CITY AND COUNTY OF SAN FRANCISCO
DEPARTMENT OF CITY PLANNING

FINAL

**SAINT FRANCIS MEDICAL BUILDING
AND PARKING GARAGE ADDITION
ENVIRONMENTAL IMPACT REPORT**

EIR CERTIFICATION DATE: MARCH 19, 1987

FIGURE 10
HEIGHT AND BULK DISTRICTS

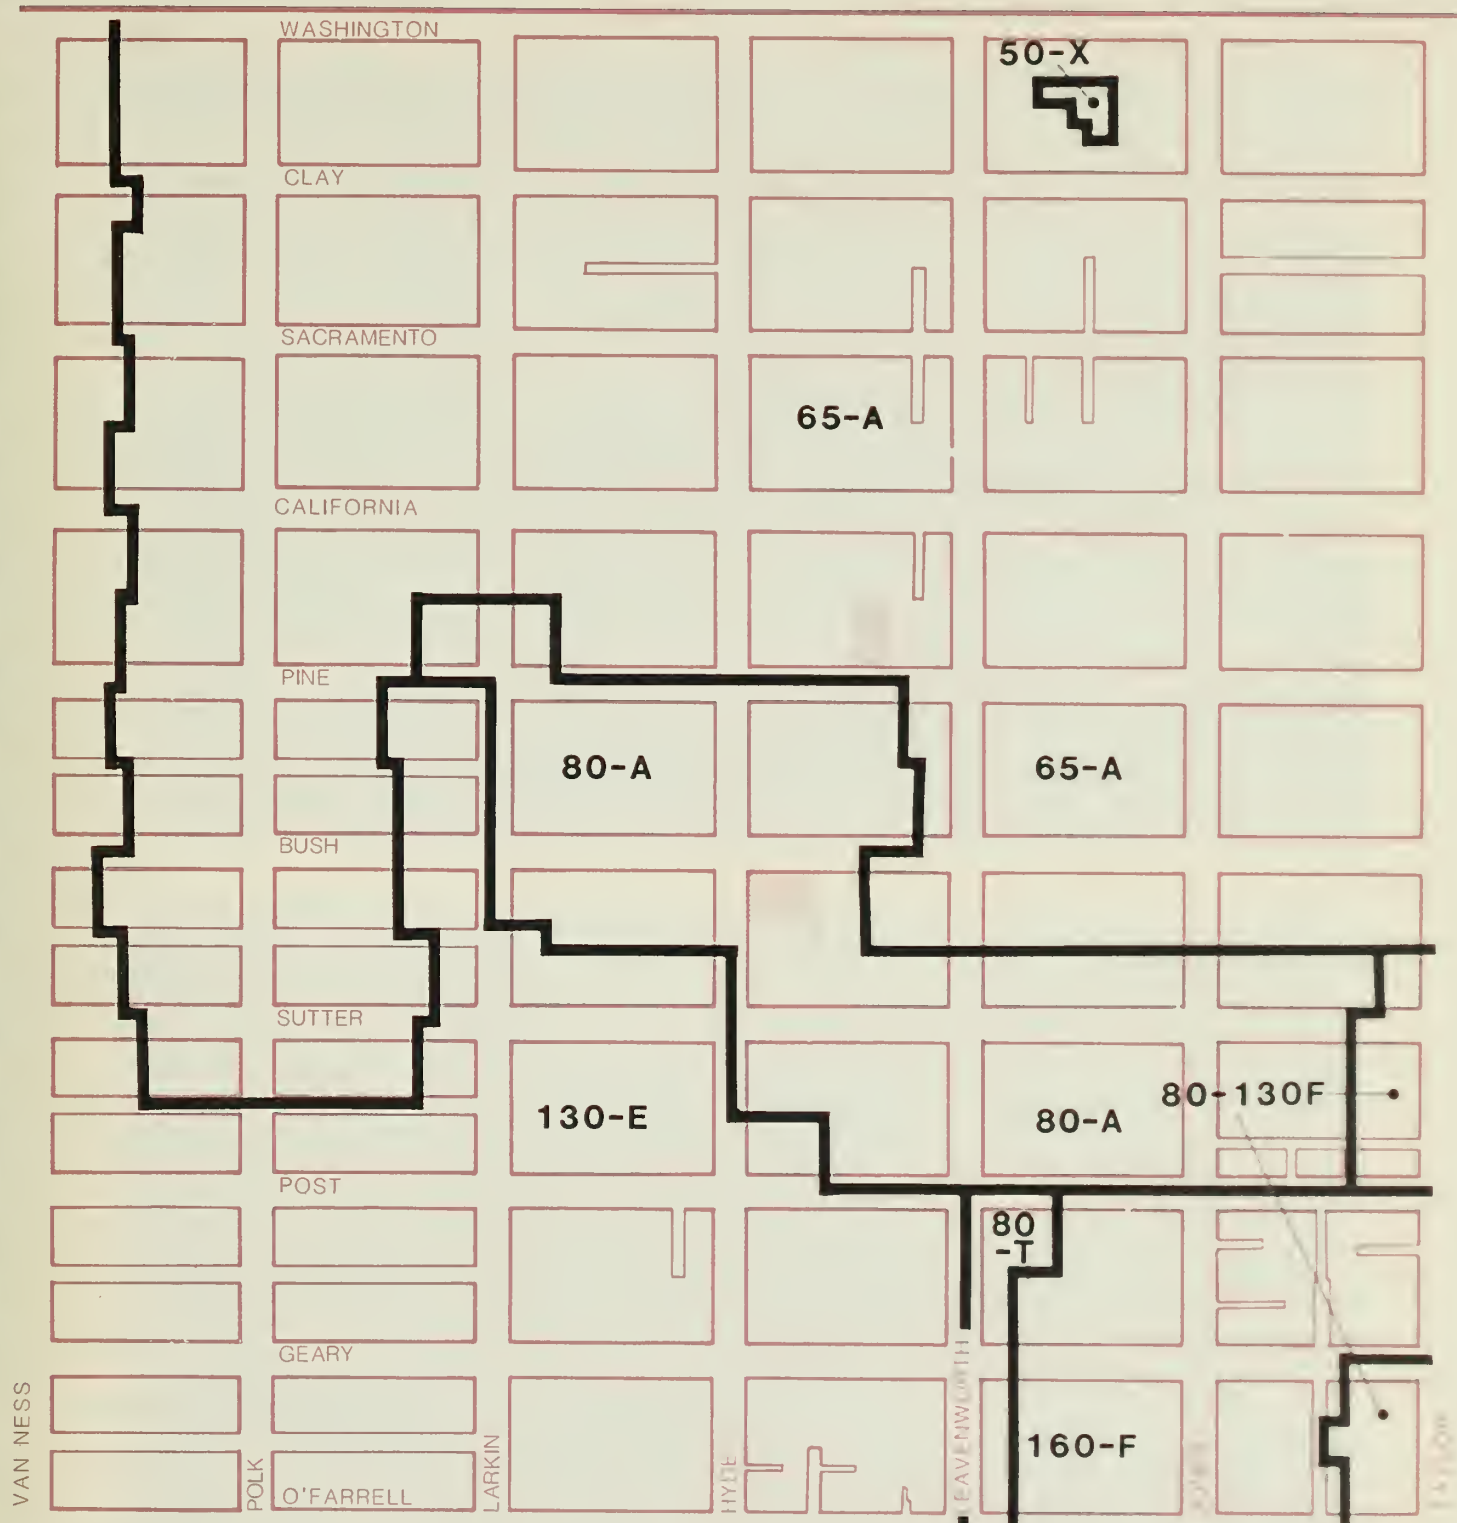
"The EIR text is incorrect in stating that the 1234 Pine Street Garage site is within an 80-A Height and Bulk District (p. 13) and is inconsistent with Figure 10 (which is correct). The garage site's maximum height is 65 ft., as shown in Figure 10 which also illustrates the extent of the exemption from the Slopes of Nob Hill Rezoning granted to the hospital." (Dorothy Dana, NHN)

The medical building site is within an 80-A Height and Bulk District (see Figure 10, p. 29), in which the allowable height is 96 ft., including an optional mechanical penthouse level of up to 16 ft. in height.

● FIGURE 17
VIEW OF MEDICAL BUILDING
FROM HYDE STREET

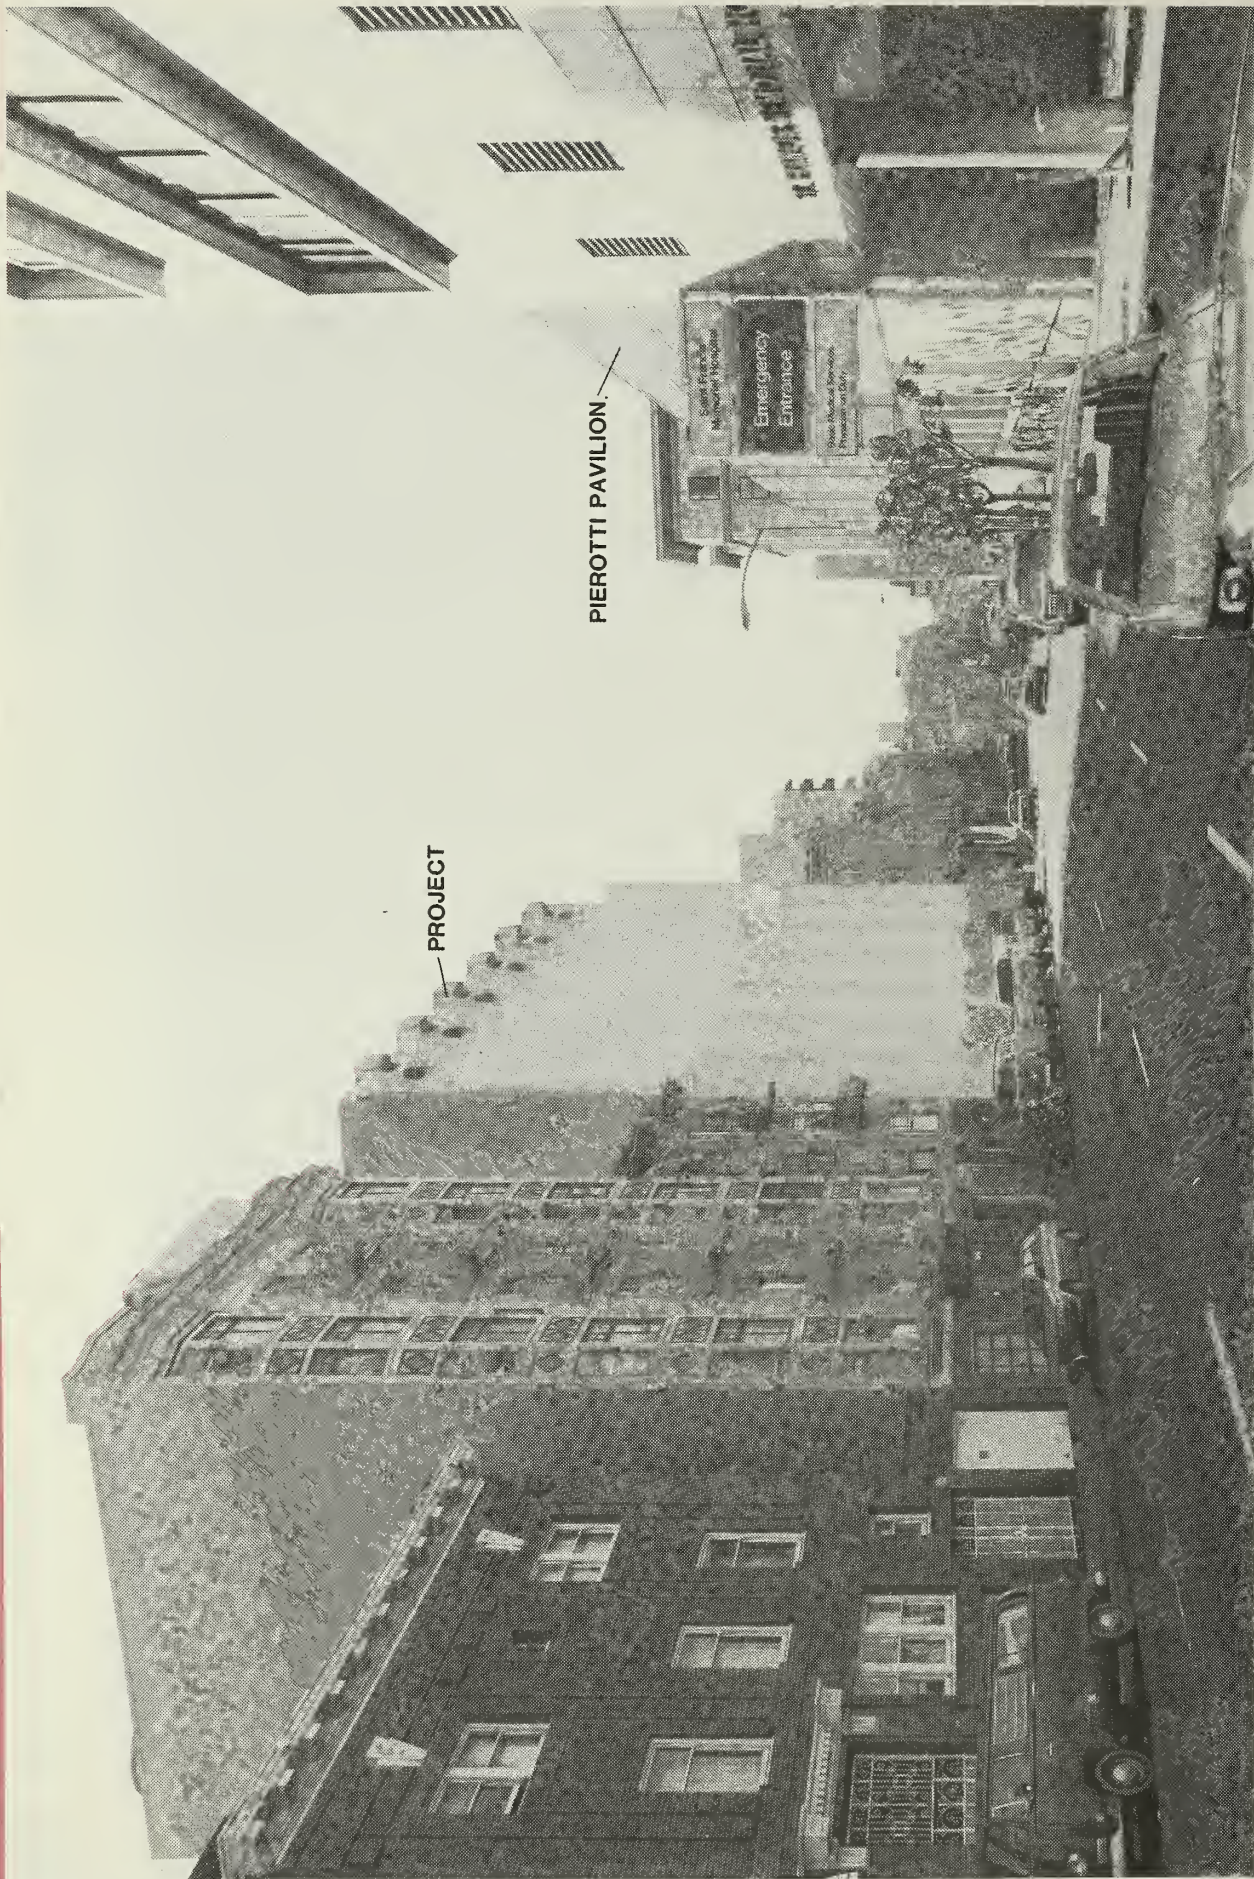
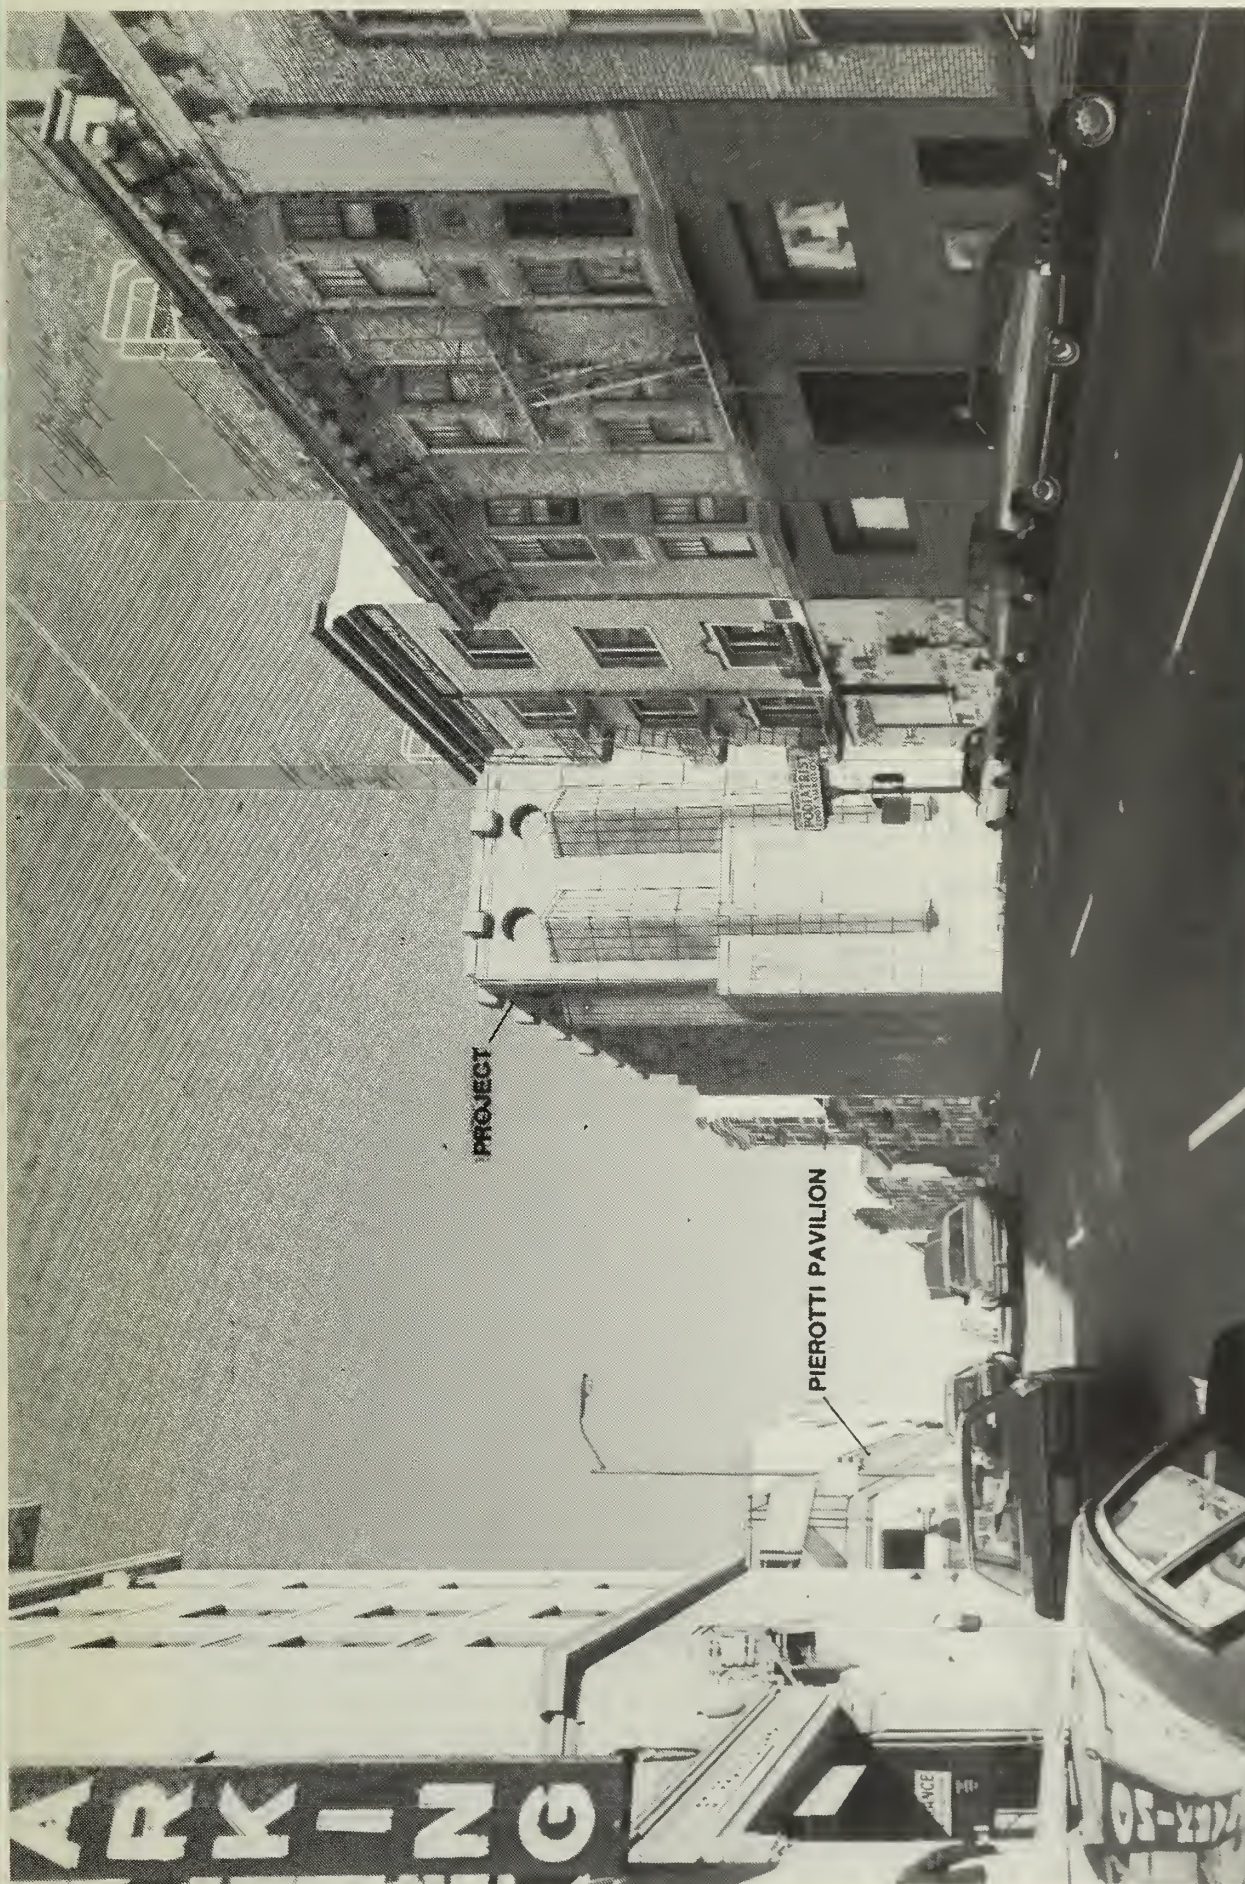
"The photomontages are inadequate because they do not illustrate the visual effects of a dark building faced with red brick veneer (as stated on p. 20) or stone and brick veneer (as stated on p. 57). As a result, the photomontages misrepresent the project as proposed, suggesting that the building would be light in color and, thus, in apparent weight and mass. Table 2 is inconsistent with the EIR text on p. 20 and Figures 17, 18, and 19. Out of what materials will the facade of the MOB be constructed? The EIR needs to clarify the sponsor's intentions and be internally consistent in describing them for readers and decision-makers." (Dorothy Dana, NHN)

"Figures 17, 18, and 19 do not illustrate the Pierotti Pavilion addition now underway (or future build-out of the pavilion as envisaged by the hospital). Consequently, these Figures provide inadequate information from which to assess the intensification of development along the corridors pictured." (Dorothy Dana, NHN)

Figures 17, 18 and 19 of the EIR are revised to include the one-level addition to the Pierotti Pavilion now under construction (see pp. 181 to 183 of this document).

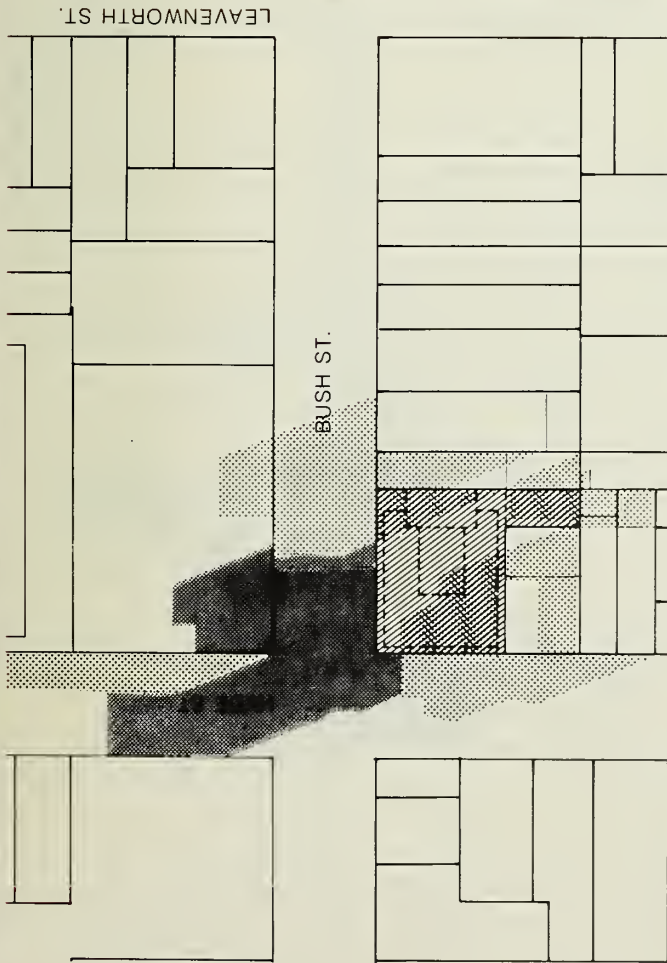
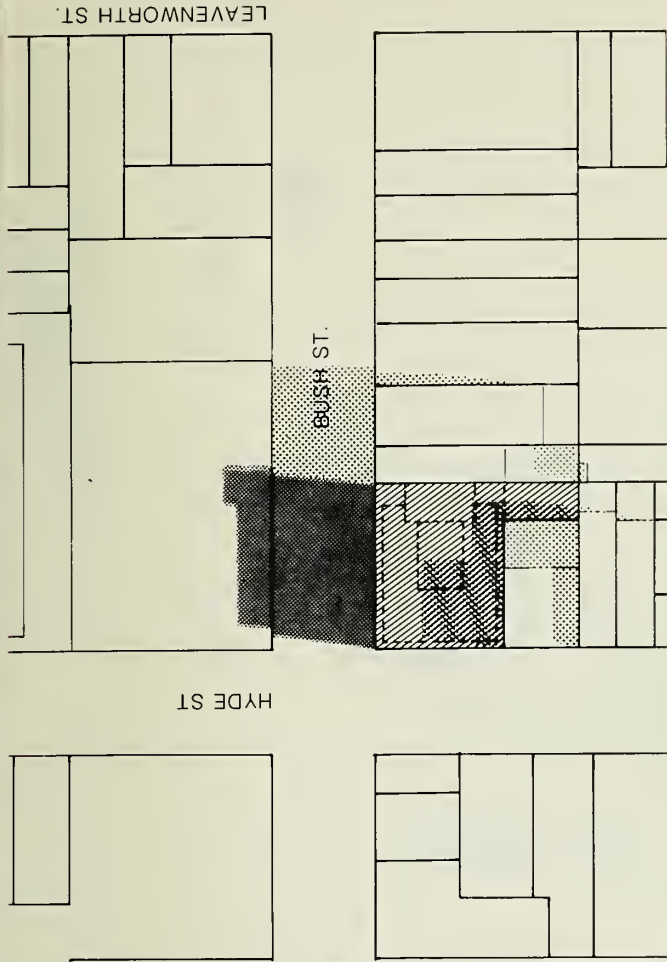
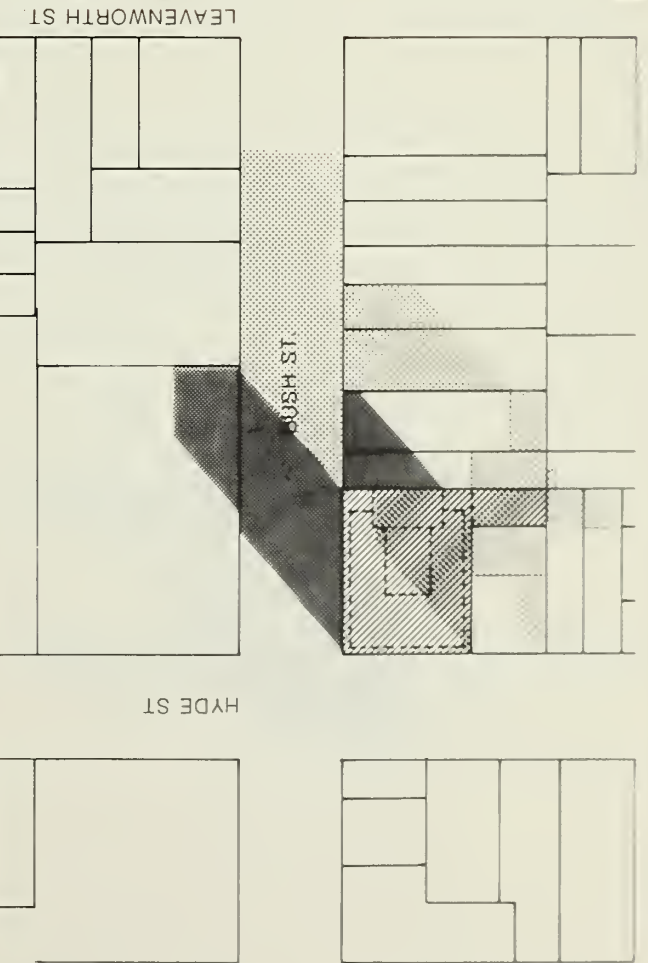
"The EIR reports that the proposed MOB would impede light and air access to the light well in the residential building east of the site. In this context, the EIR fails to assess the usability or liveability of the garden proposed as part of the project.

"The public garden proposed for the MOB would be in shadow virtually all the time due to existing buildings. What alternative sites for such public open space were assessed in the environmental review process to determine the likelihood that this garden would be used? If no alternative sites were analyzed, did the EIR preparers assess the relative merits of proposing open space which would be accessible to the public but which would not provide sunlight?" (Dorothy Dana, NHN)

The outdoor garden proposed for the rear of the medical building would not be in shadow at all times. The Shadow Pattern diagrams for the proposed Medical Building (Figures 21-24) of the Draft EIR did not take into account the rear-yard setbacks of the existing buildings adjacent to the property line of the Medical Building site to the east and to the south. Figures 21-24 are revised to reflect these setbacks (see pp. 188 to 191 of this document and will be inserted in the EIR).

FIGURE 6
PARKING GARAGE ADDITION
PINE STREET ELEVATION
AND BUILDING SECTION

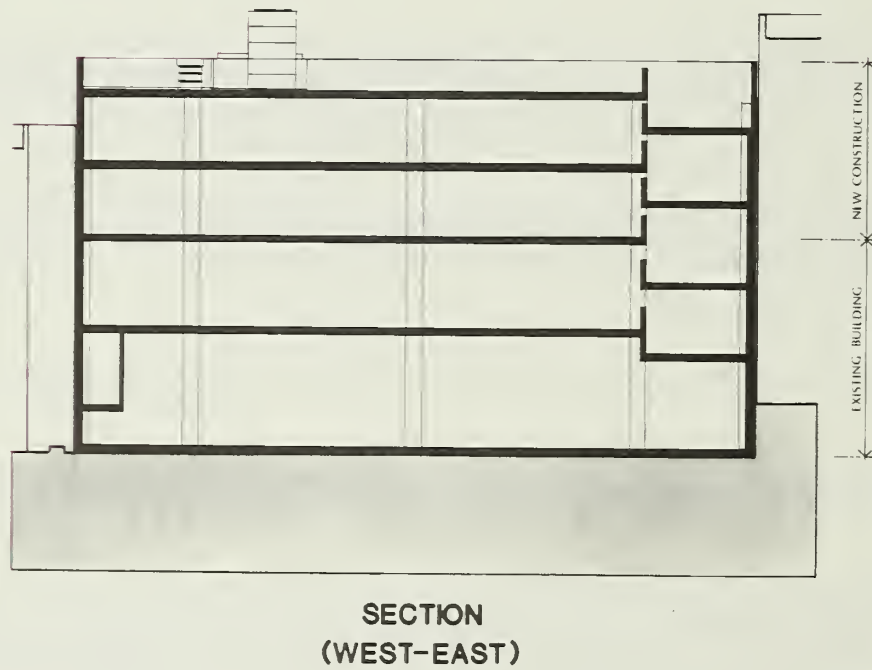
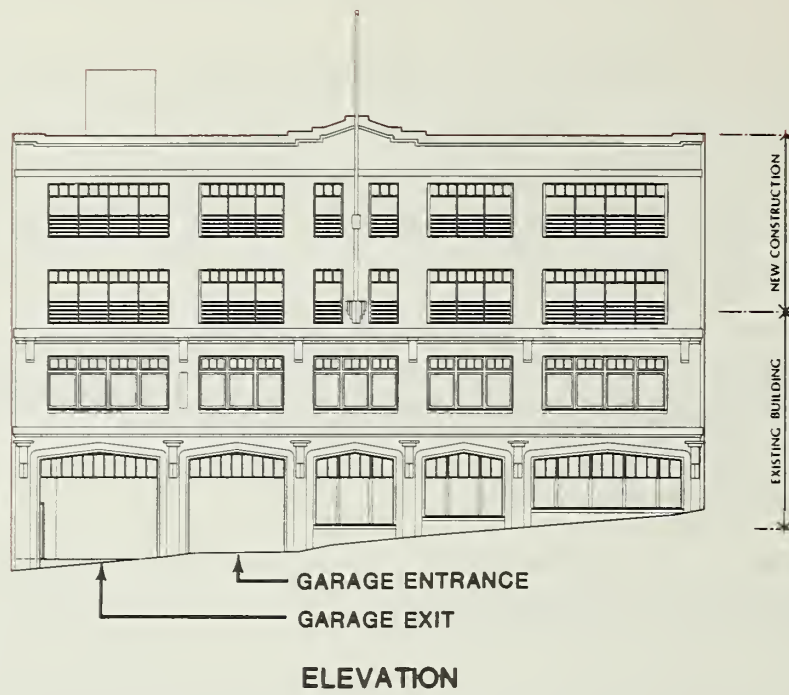
"The evening traffic pattern is also not adequately addressed. There has been no discussion of how long the designers of this garage expect the 200 or more autos therein to take to exit the premises at the evening rush. The time scale of this exit operation is complicated by the extremely heavy vehicular traffic on Pine Street into which the cars will be existing, requiring substantial wait between individual auto's access to the street." (Richard Grabstein)

Figure 6 on p. 21 of the EIR has been revised to reflect this change (see p. 207 of this document).
